# Intel® Xeon™ MP Processor

## Specification Update

*August 2003*

Document Number: 290741-018

#### System Bus AC Specifications (Reset Conditions)

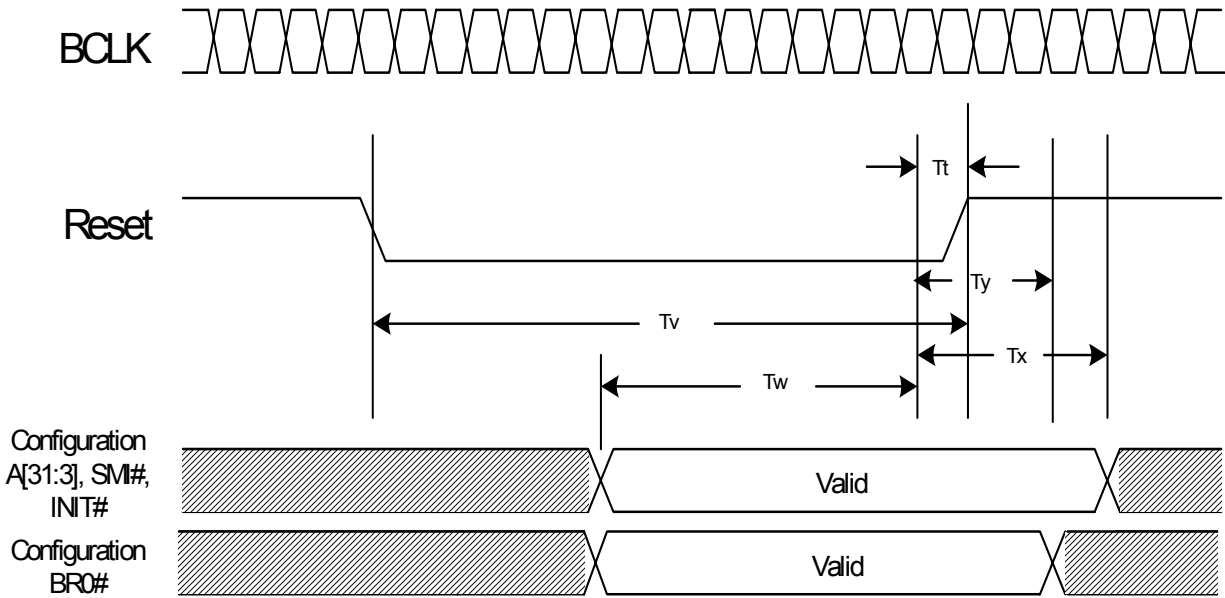
### O1: BR0# Maximum Hold Time Specification Change

The BR0# maximum hold time has changed to 2 BCLKs. This change will be shown in the "System Bus AC Specifications (Reset Conditions)" table and "System Bus Reset and Configuration Timings" figure of the above mentioned datasheets. This change will be incorporated in the next revision of the above datasheets.

Signals (A[31:3]#, INIT#, SMI#) Hold Time					
T47: Reset Configuration Signal BR0# Hold Time	2	2	BCLKs	12	2

The following figure will be modified to reflect this change:
